Hastings Secondary College Upgrade | Port Macquarie Campus / Response to DPIE Request for Information

SINSW SSDA — REV 1 — 13/10/21

## **Additional questions and request for information:**

# CAPA Level 1

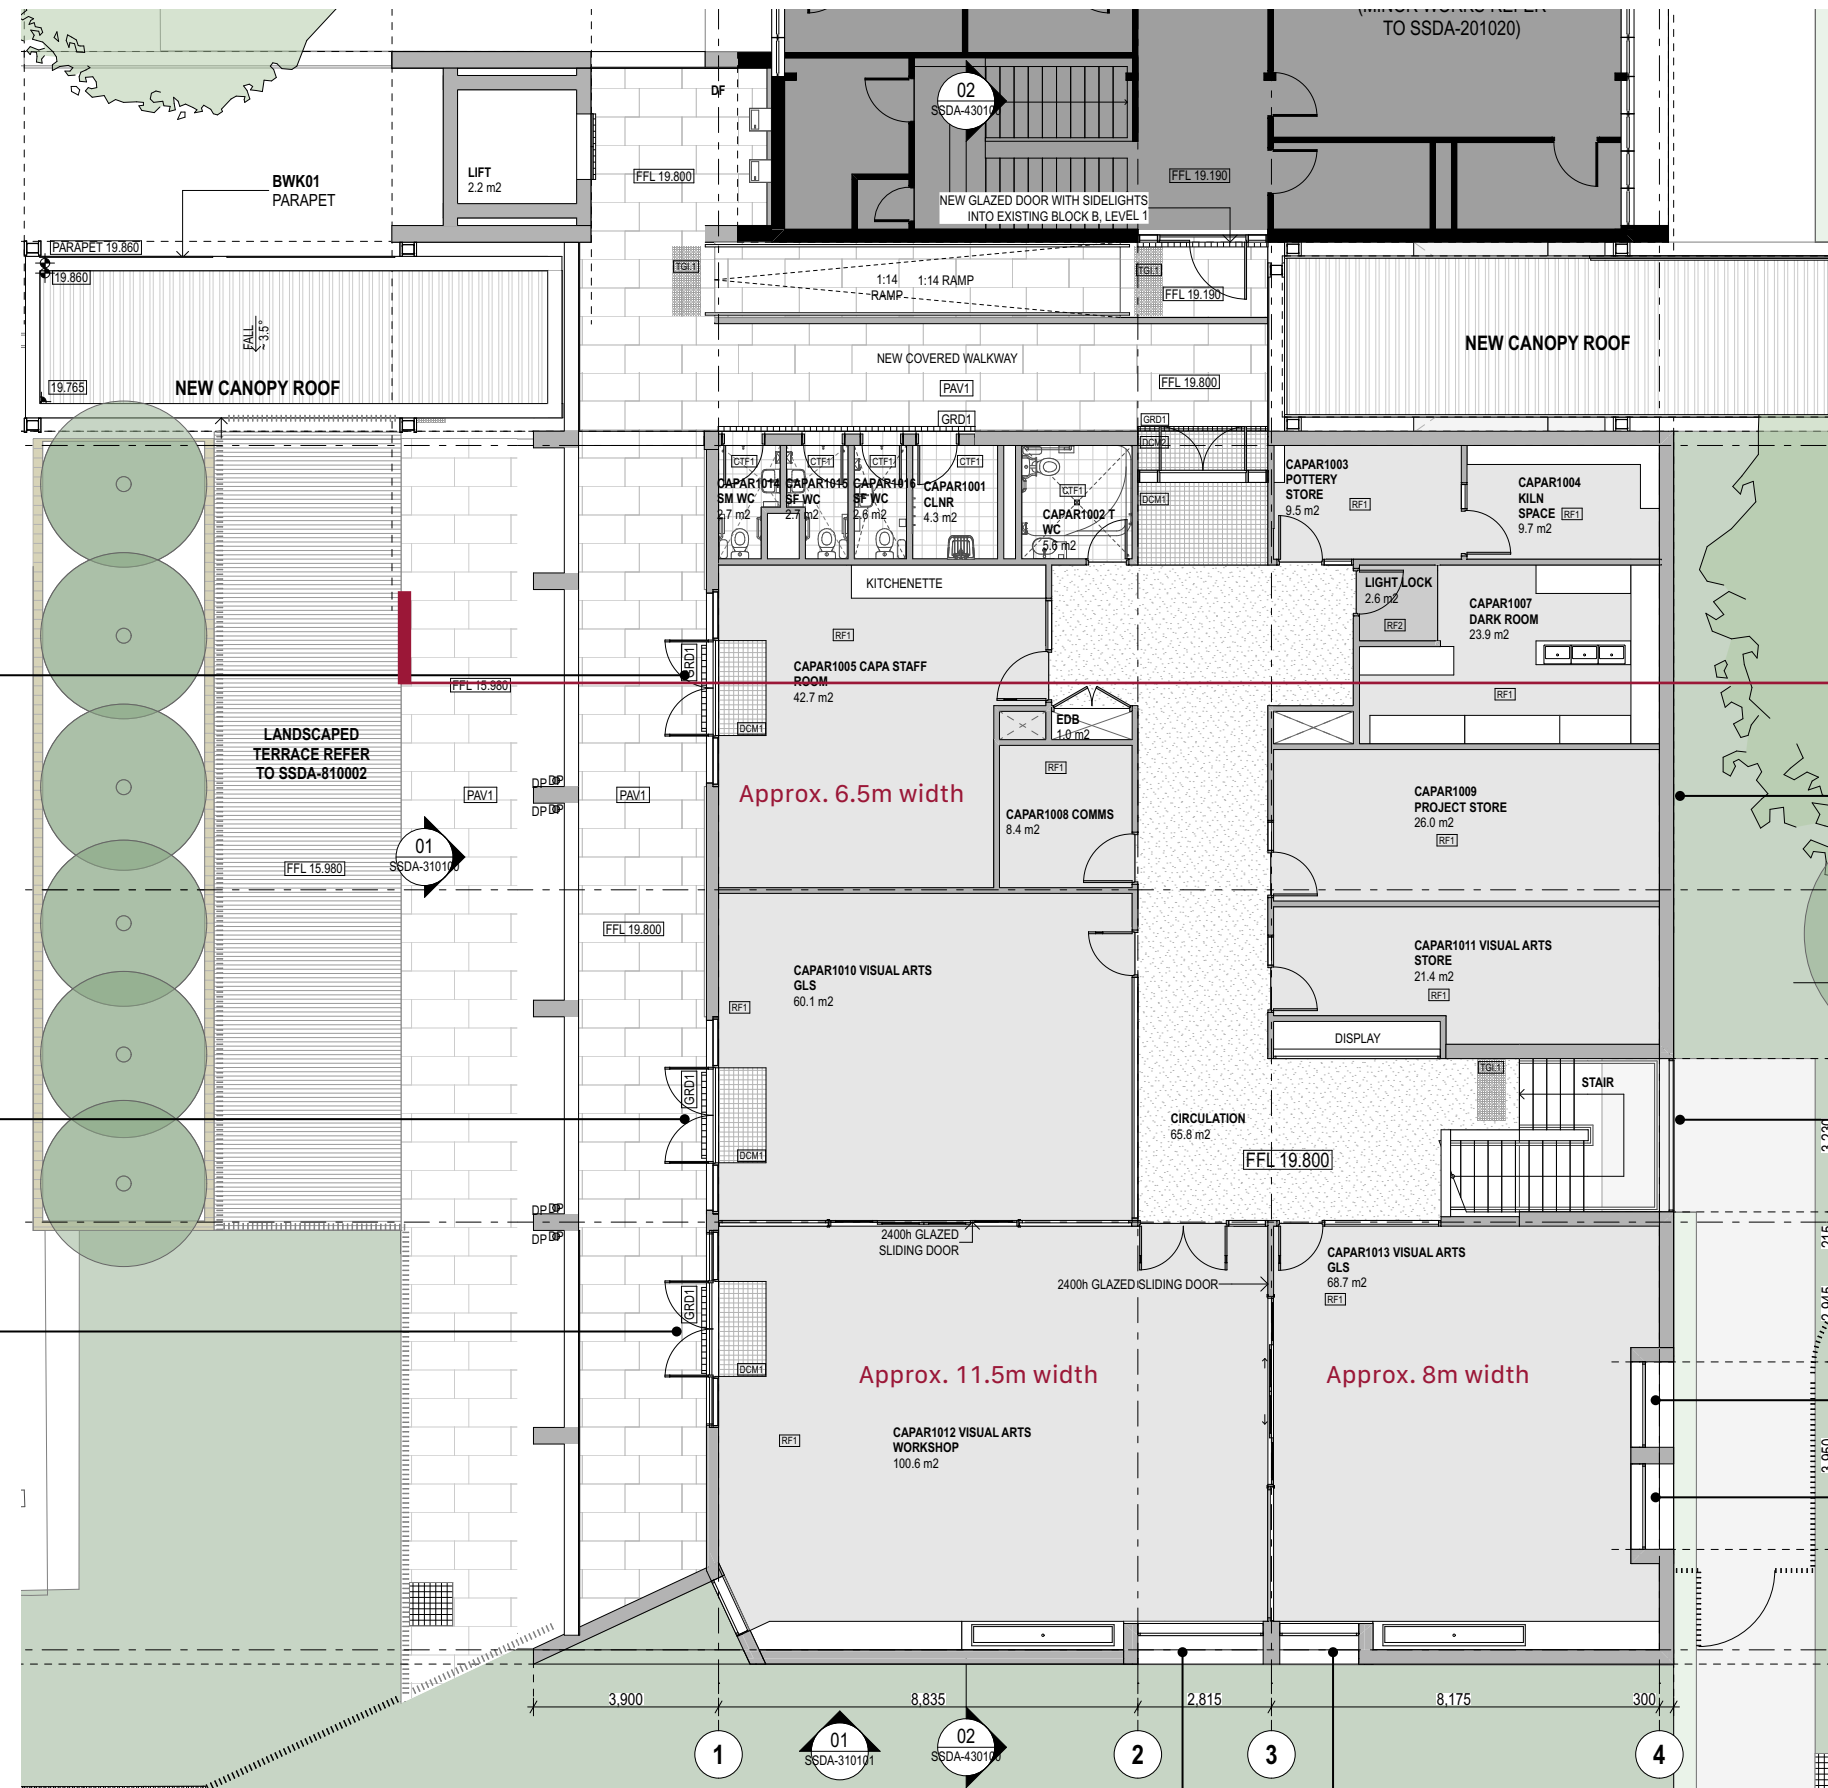
*It is recommended that opportunities for operable glazing be investigated in the CAPA building, which appears to have predominantly fixed glazing.*

**Each window bank to have a zone of mechanical fresh air intake louvres. In active louvres to be blanked off.**

**Windows recessed between brick piers/  
columns to provide east/west shading**

2 x aluminium framed glazed door with operable glazed louvre side lights.

2 x glazed openable awning windows (with limiters) - 1000 mm - 2400 mm.

2 x glazed openable awning windows (with limiters) - 1000 mm - 2400 mm.
